SERVICE ALERT

Issued 12th June 2015

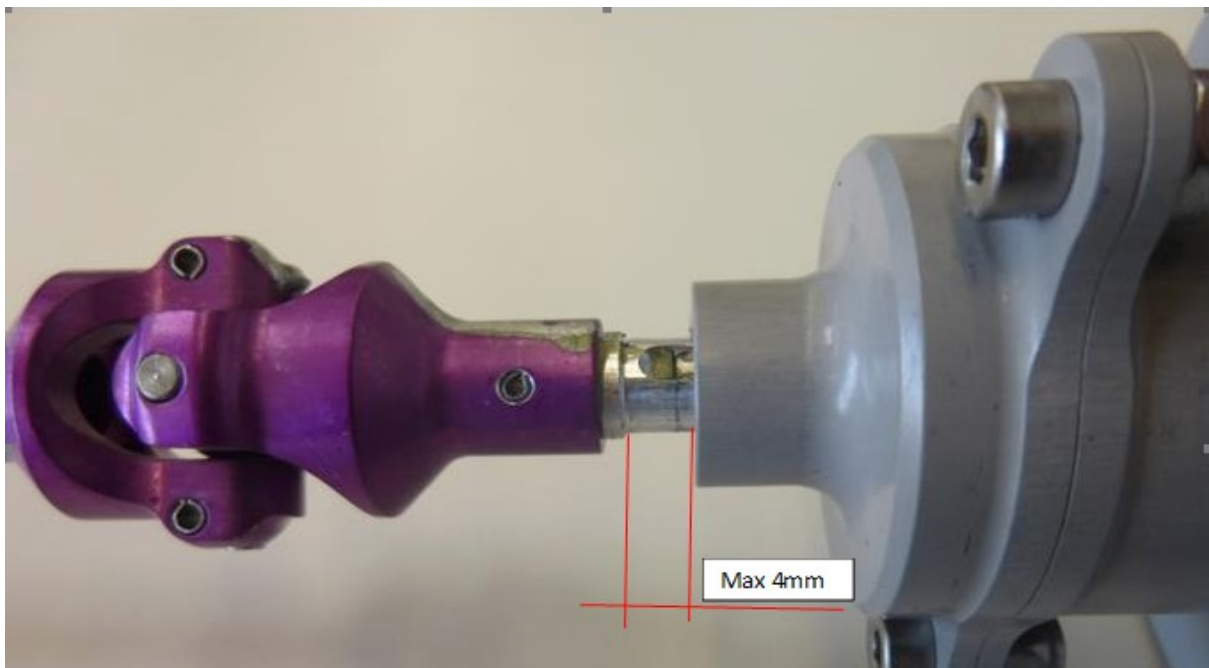
This Service alert applies to all Diamond Aircraft fitted with this extension system. It has been brought to our attention that there could be a possible lack of engagement between the universal joint assembly and the top of the valve assembly. It is requested that a check be carried out to establish a minimum of engagement of 5mm with the dowel in the valve assembly. The picture below gives a maximum dimension of 4mm. Less than this can be considered satisfactory, this gives over 5mm engagement. Greater than this, the assembly should be investigated further and a new longer dowel be fitted. The longer dowels can be supplied.
